**SECTION 00 90 02
BIDDING AND CONTRACT REQUIREMENTS
ADDENDUM NUMBER 2**

Re: ADDENDUM NUMBER (2) TO THE BIDDING DOCUMENTS FOR

**Student Farm Renovations
Issued for Bid**

Architect's Project Number: 25-037

1 FAN - KITCHEN WITH MAU - GAS

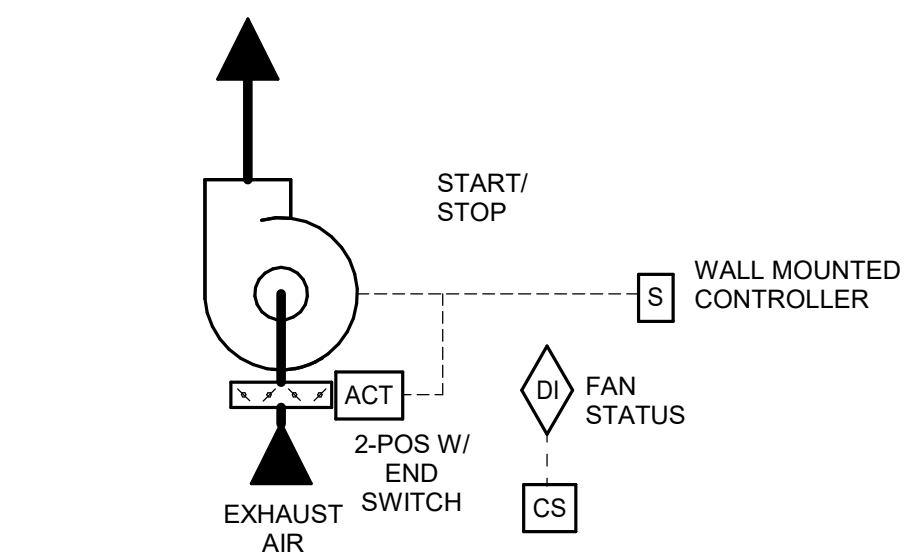
1. M1.01
 - A. **REVISE** callout to gas meter to clarify meter is to be provided and installed by utility company.
2. M3.00
 - A. **ADD** Sheet Notes 1 & 2.
 - B. **REVISE** 1/M3.00 Fan – Kitchen with MAU – Gas Control diagram. Reference to FMCS removed and sequence updated.
 - C. **REVISE** 4/M3.00 Unit Heater Control – Electric. Reference to BAS removed.
3. M4.00
 - A. **REVISE** Unit Heater Schedule – Electric (UH) Note 1. Reference to BAS removed.
 - B. **REVISE** Furnace Schedule Note 1 & 2. Reference to BAS removed & humidifier scope clarified.
 - C. **REVISE** Make-up Air Unit Schedule (MAU) Note 1. Reference to BAS removed.

2. PRE-BID RFI #1: Drawing M3.00 mentions a FMCS – Facility Monitoring and Control System. I don't see anything in the documents that lists a control contractor for this project. Can you find out who we need to contact for the control monitoring?

- A. RESPONSE: References to a FMCS/BAS on M3.00 diagrams are an error. Project intent is for equipment-level controls, MAU and kitchen exhaust fan controls shall be integrated with hood controls as required. Clarification of documents to be included in forthcoming addendum.

- CONTRACTOR RESPONSIBLE TO PROVIDE ALL SENSORS, WIRING, RACEWAY, ETC. AS REQUIRED TO COMPLETE SCOPE OF WORK.
- CONTROL POINTS SHOWN ARE LOCAL TO EQUIPMENT UNLESS OTHERWISE NOTED. NO BAS OR FMCS CONNECTION REQUIRED.

5 FIRE ALARM RISER DIAGRAM
 NO SCALE

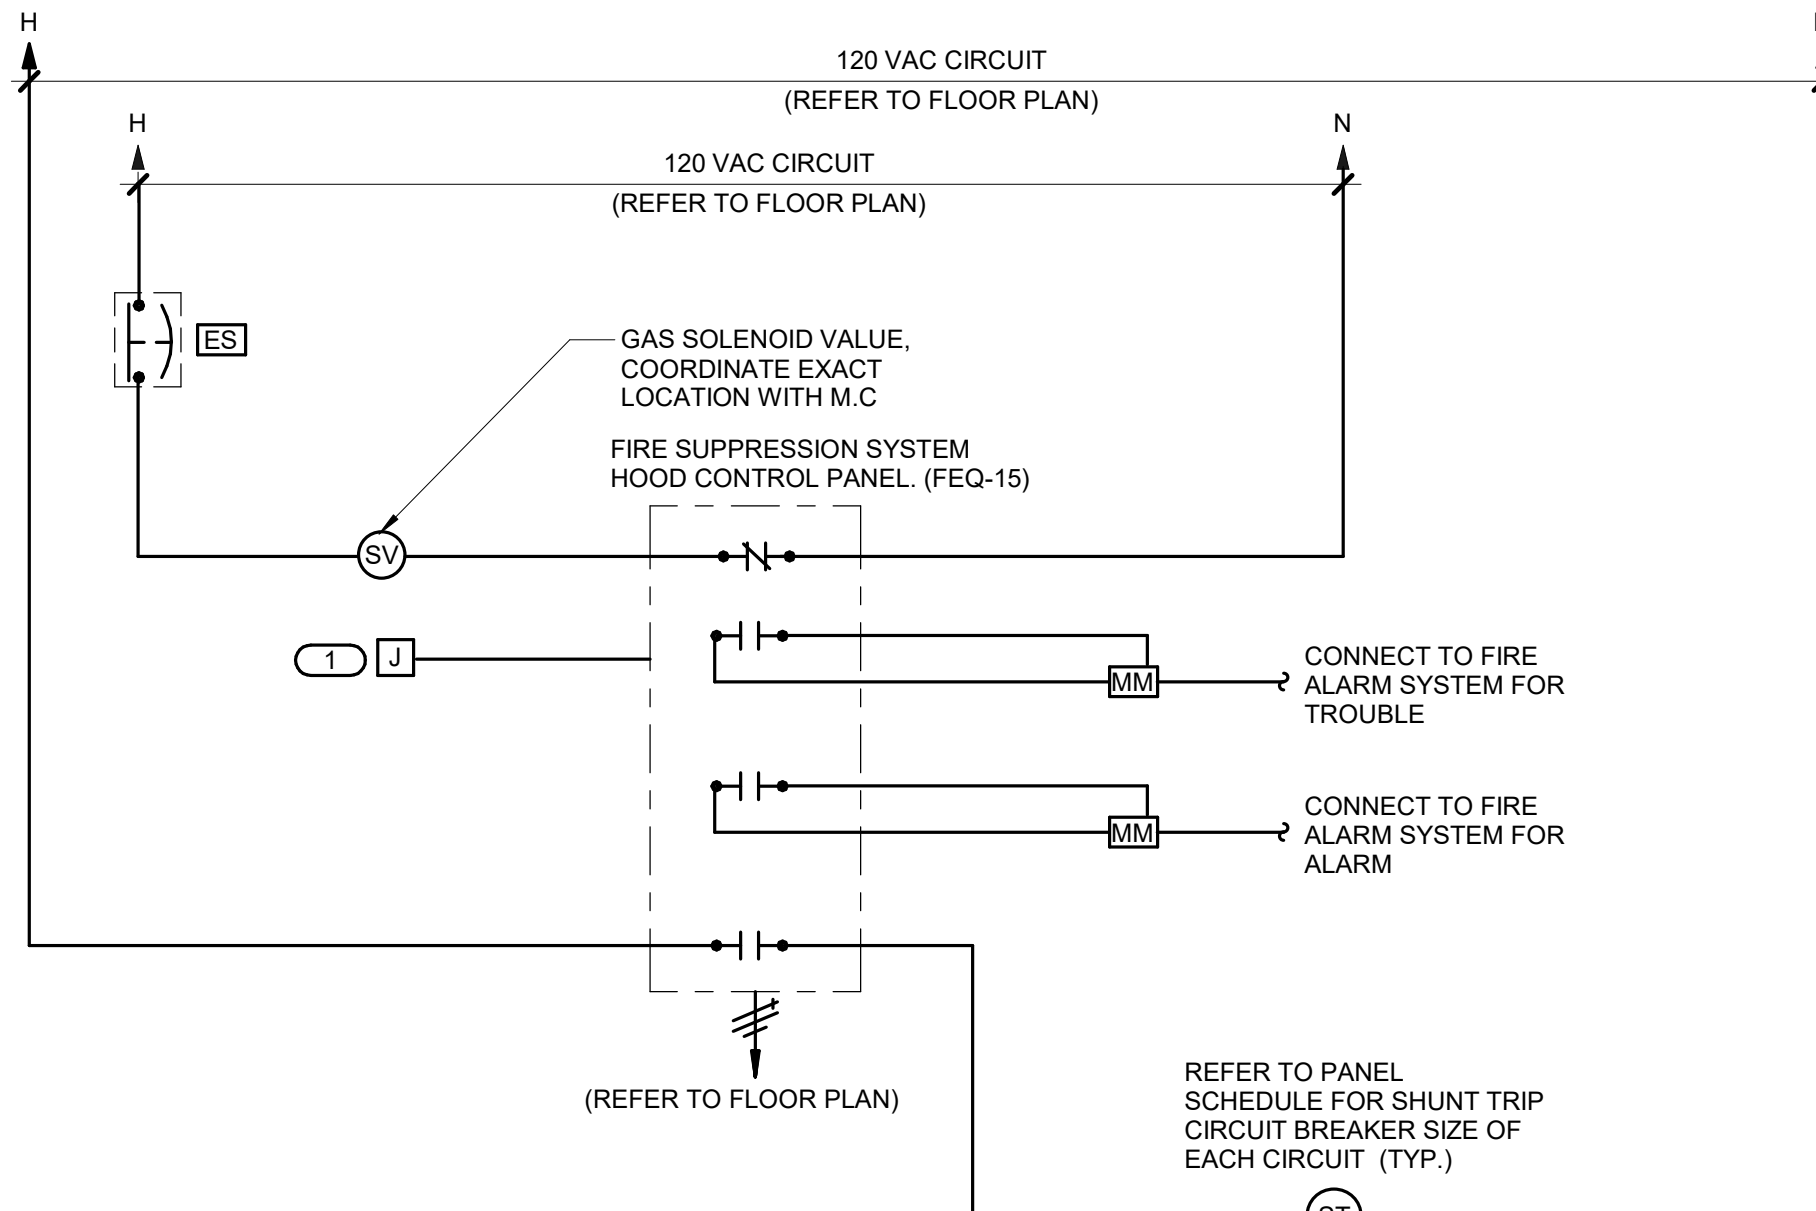
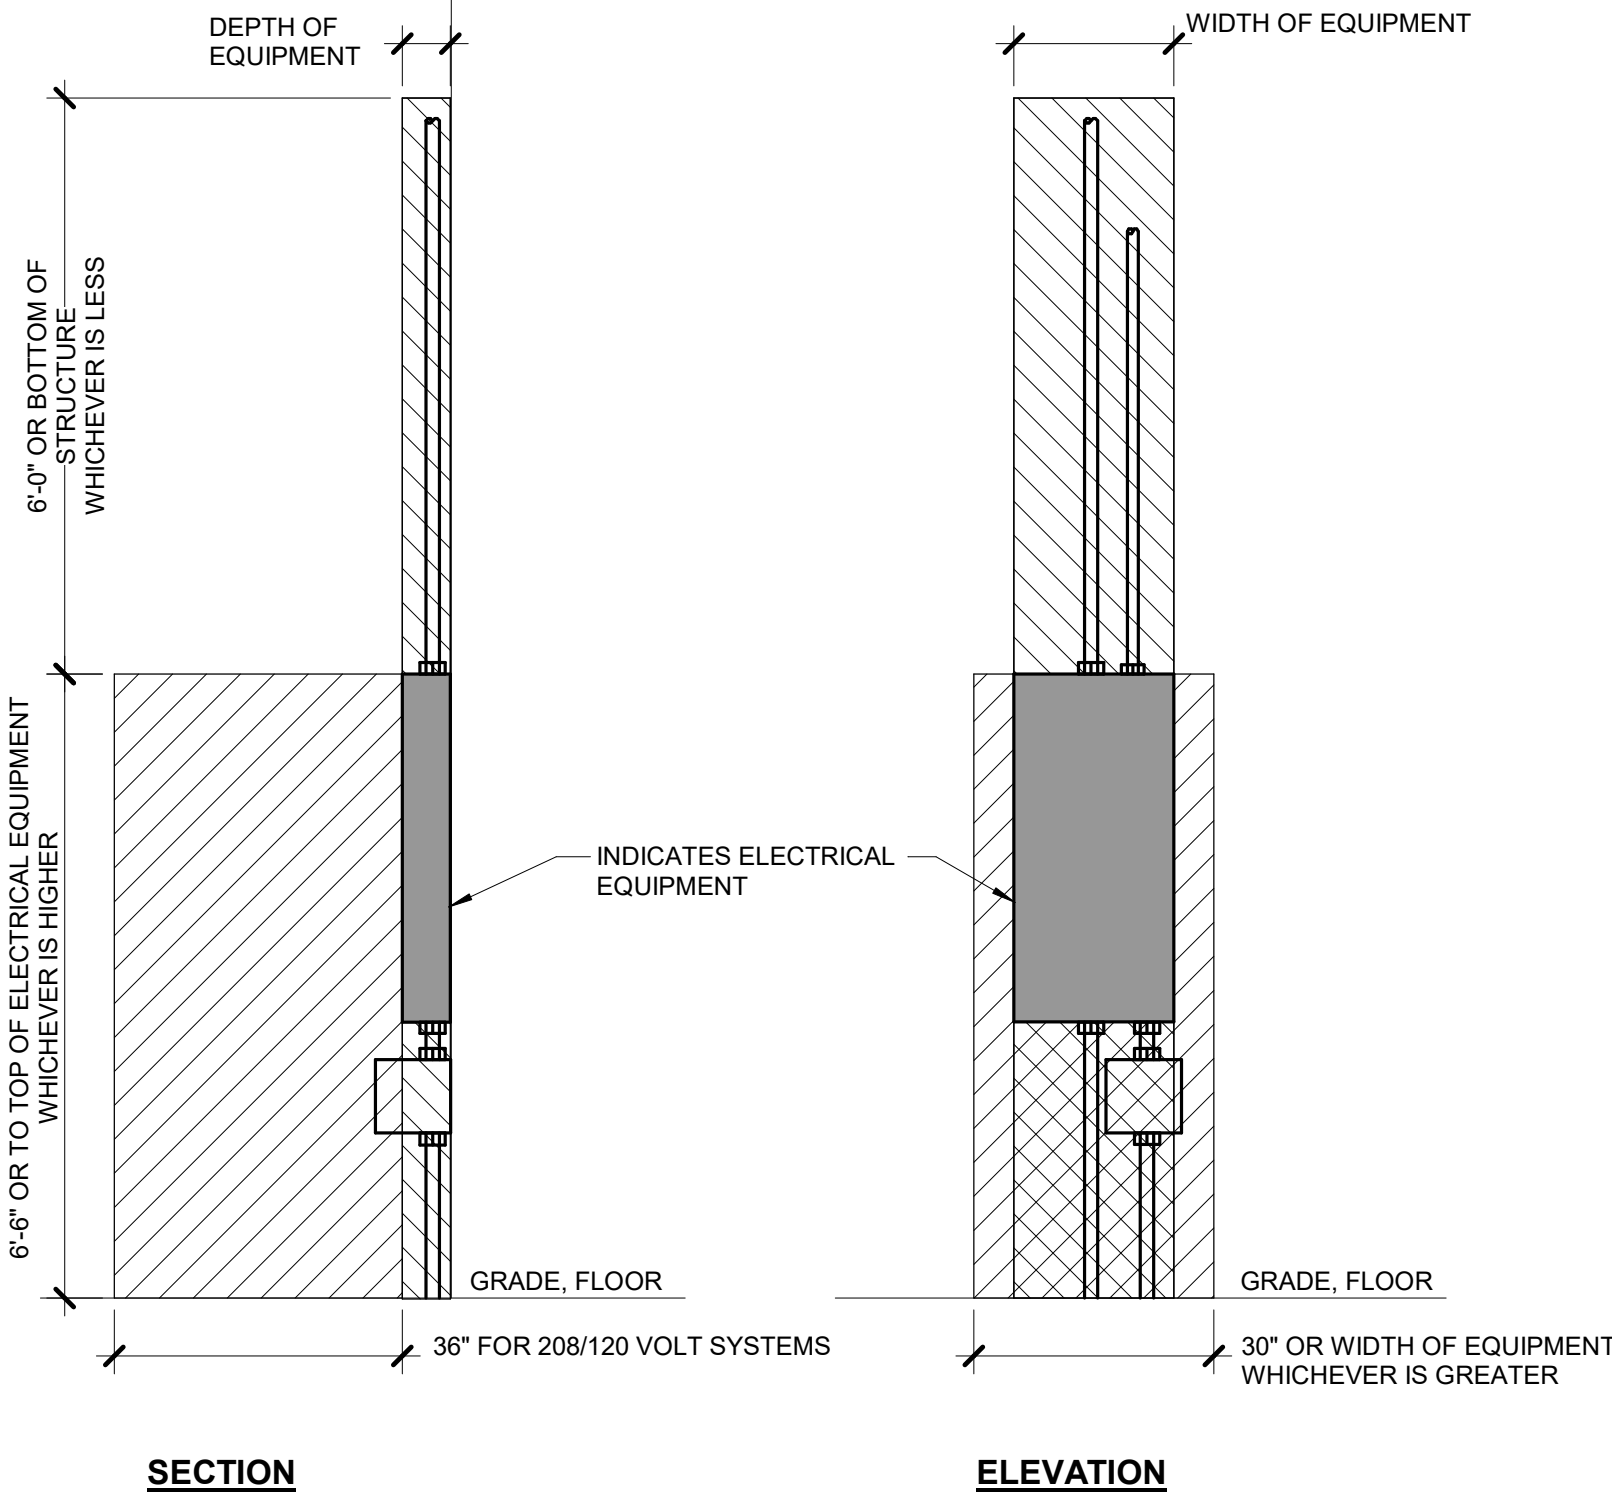
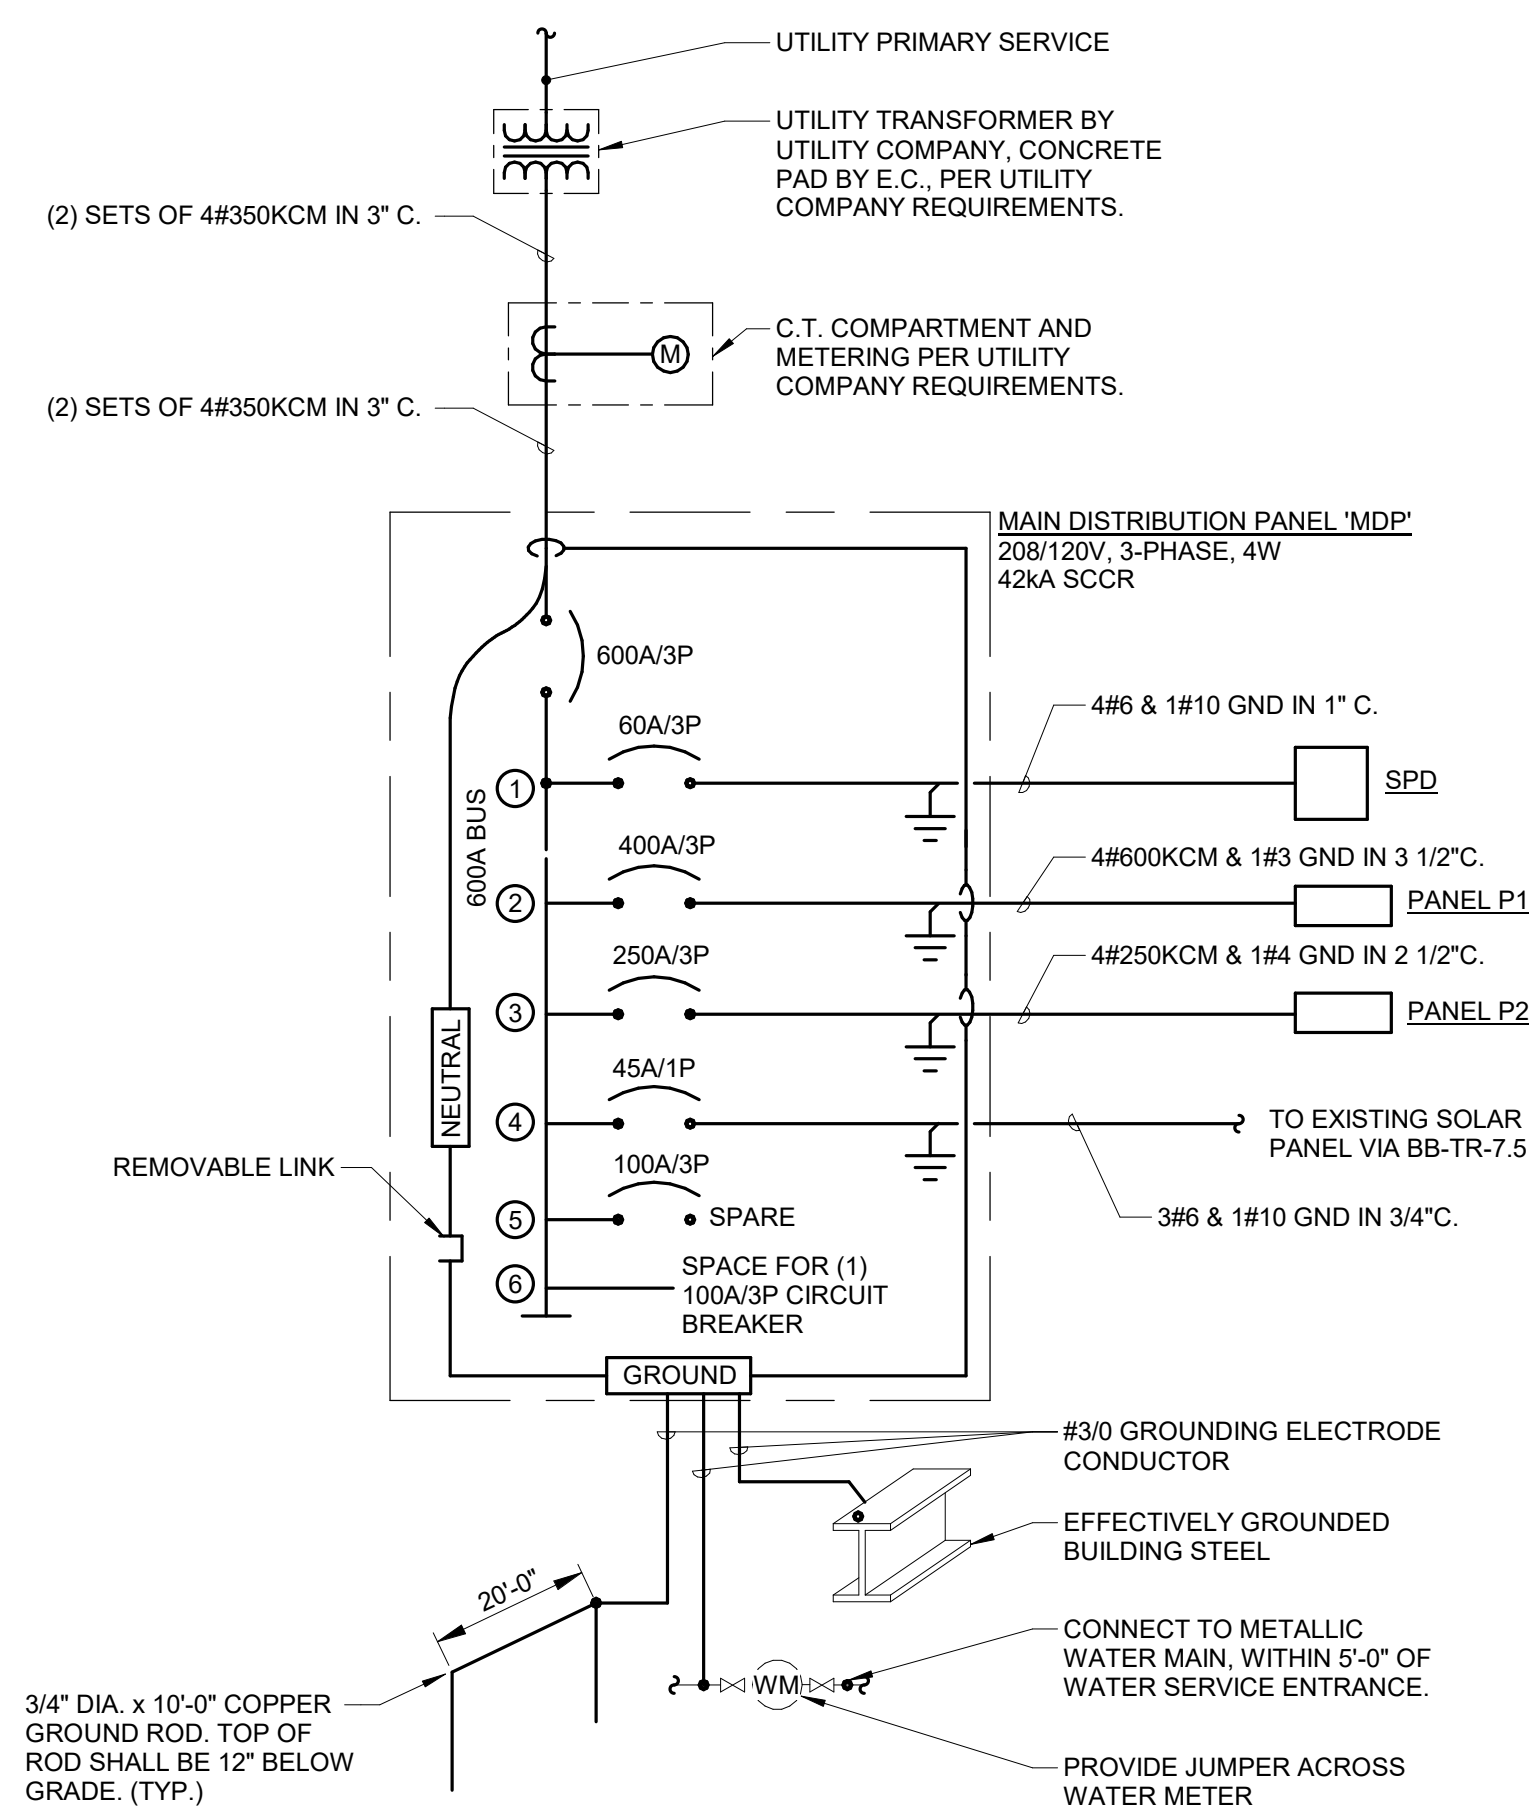
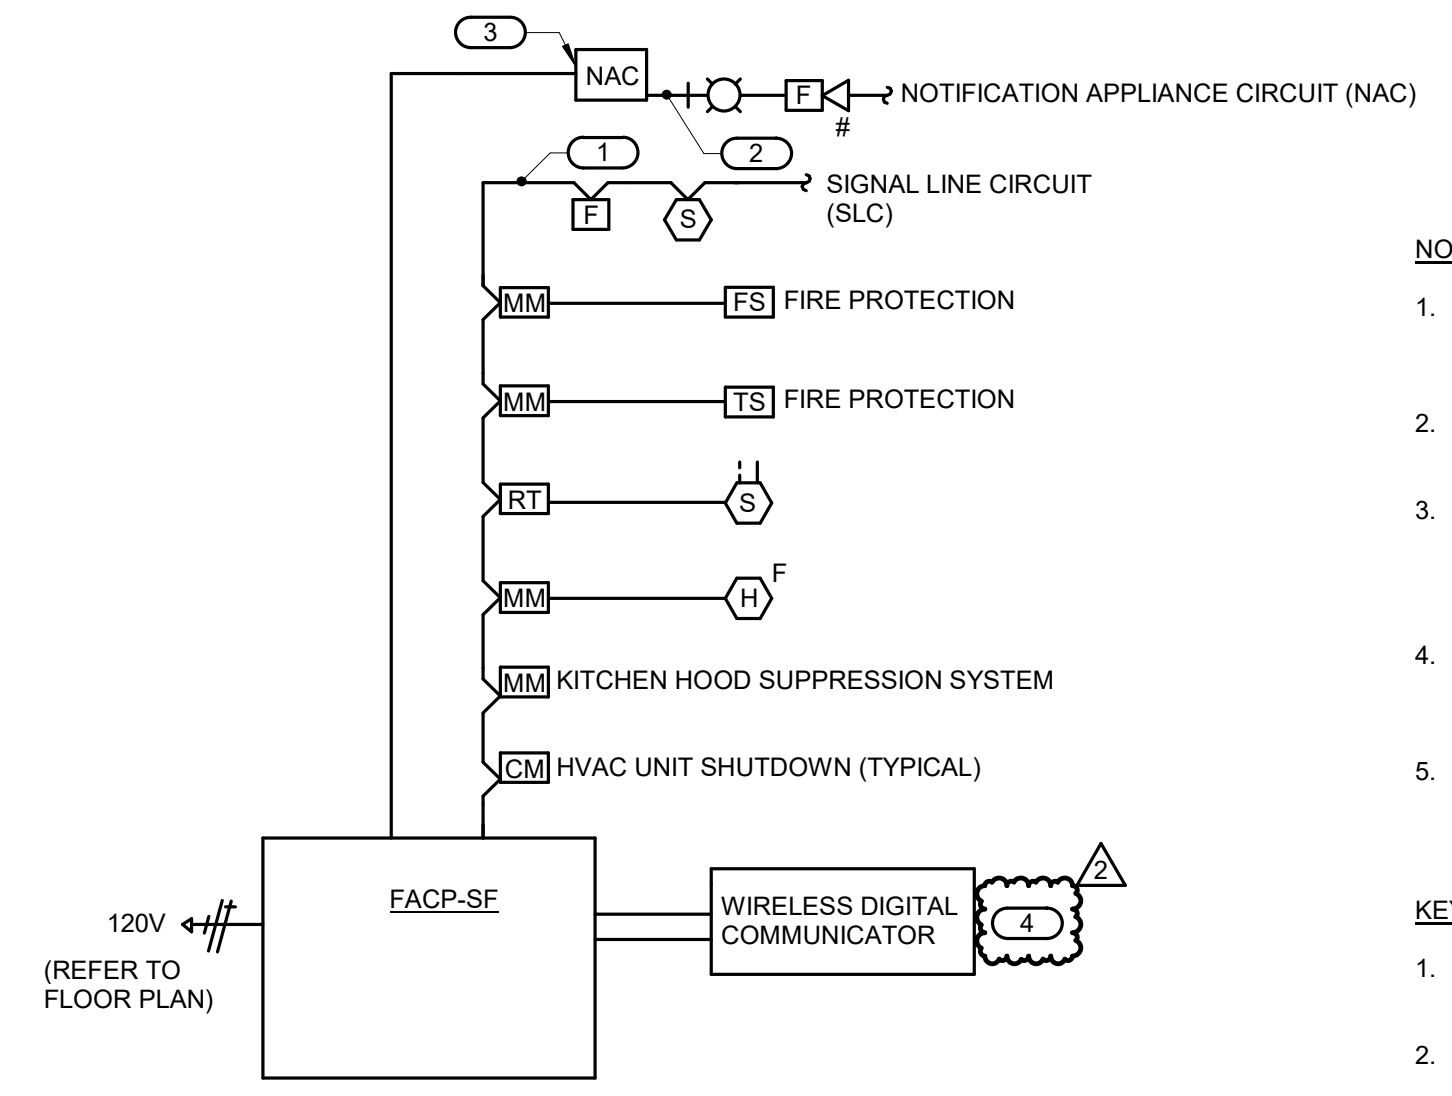
1. E2.00
 - A. **REVISE** 5/E2.00 – FIRE ALARM RISER DIAGRAM.

3. PRE-BID RFI #2: We didn't see any fire alarm manufacturer requirements in the specifications. Can you confirm the new FACP does not need to match the existing building manufacturer and does not need to be tied into the existing campus system?

- A. RESPONSE: The new FACP should match the existing campus standard, Notifier by Honeywell. The design intent is for a standalone system that will operate with the campus via a wireless communicator connecting the standalone FACP at the student farm building back to central campus. Refer to revised drawings and specs for additional clarification.

3. PROVIDE NOTIFICATION APPLIANCE EXTENDER PANELS AS REQUIRED.
 4. WIRELESS COMMUNICATOR SHALL COMMUNICATE TO THE MAIN FIRE ALARM CONTROL PANEL SERVING THE CAMPUS. THE MAIN CONTROL PANEL IS LOCATED IN THE POLICE DEPARTMENT AREA (NOTIFIER NFS2-3030). PROVIDE ALL REQUIRED HARDWARE AND PROGRAMMING TO ALLOW CONNECTION OF THE NEW FACP-SE.
